Work Order ID 83808

Item Name: Crosstube Turning Detail

DART AEROSPACE LTD	Work Order: 83808
Description: Crosstube Assembly (412 High Aft)	Part Number: D412-664-243
Inspection Dwg: D412-664-243 Rev: E	Page 1 of 1

DRAWING NO. D412-664-243	TITLE CROSSTUBE ASSEMBLY (412 HI AFT)	REV. E	DART AEROSPACE LTD ENGINEERING ORDER		D.E.O. NO. D412-664-243-E-1	SHEET NO. SHEET 1 OF 2	SCALE NTS
DRAWN	CHECKED	MFG. APPR.	APPROVED	DE APPR.			
DATE 11.03.31	DATE 11/03/31	DATE 11.03.31	DATE 11/03/31	DATE 11-03-31

D212-664-243
ASSEMBLY DETAIL

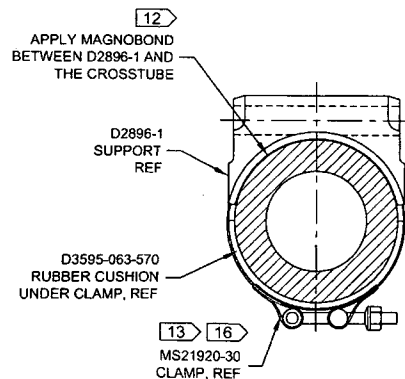
PURPOSE:

REMOVED ABRASION STRIP IN FAVOR OF A THIN LAYER OF PROSEAL 890.

NOTES 2 AND 14, SHEET 1 ARE AMENDED AS FOLLOWS:

IS:

D3189-1 CHAFING SHIELD (1, INSTALLED OVER PROSEAL 890)
MS21920-28 CLAMP, 2X
2 PL

WAS:

D2856-600-1009 ABRASION STRIP
D3189-1 CHAFING SHIELD (1, INSTALLED OVER ABRASION STRIP)
MS21920-28 CLAMP, 2X
2 PL

MASK AREA PRIOR TO PAINTING AND
APPLY CLEAR COAT AFTER PAINTING
